Boundary Creek, Big Swamp and surrounding environment Remediation and Environmental Protection Plan

Amended: 27 February 2020

1 Response to Southern Rural Water's feedback

1.4 Feedback register

Figure 6: Conceptual water balance of Boundary Creek during the summer dry period prior to remediation

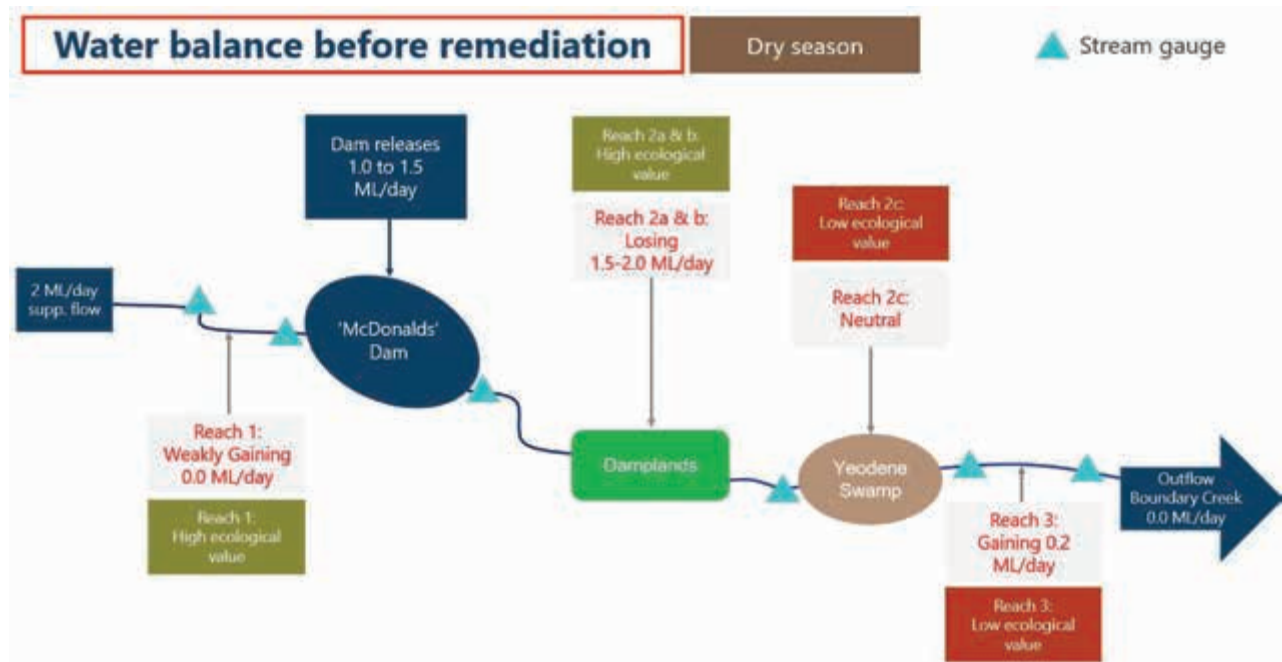
Feedback	
18	Figure 6 - The conceptual diagram indicates losses between McDonalds Dam and Big Swamp are between 1.5 - 2.0ML/d, this suggests that in dry weather (when inflows to McDonalds dam are 0, then a release of 2ML/d is unlikely to make it to Big Swamp. Are these losses included in the SW/GW modelling and the options assessment? Reach 2c (Big Swamp) is identified as neutral in regards to water balance. What is the estimated volume of Evapotranspiration/evaporation/drainage from the swamp and how does this compare to other water balance components?
19	Based on the evidence presented in the Jacobs SW/GW modelling report that acknowledges <i>'the available groundwater level records for bores in the swamp (June to September 2019) is of insufficient duration to allow a robust transient calibration that tests the model over a range of climatic and surface water hydrological conditions'</i> and concludes that <i>'a continuous release of water and installation of hydraulic barriers can be expected to increase groundwater levels throughout the swamp and to maintain flow in Boundary Creek, however this would need to be confirmed with further modelling...'</i> It is important to highlight that the flow and barrier option is unconfirmed and further modelling and site trials are required before confidence in this option can be improved.
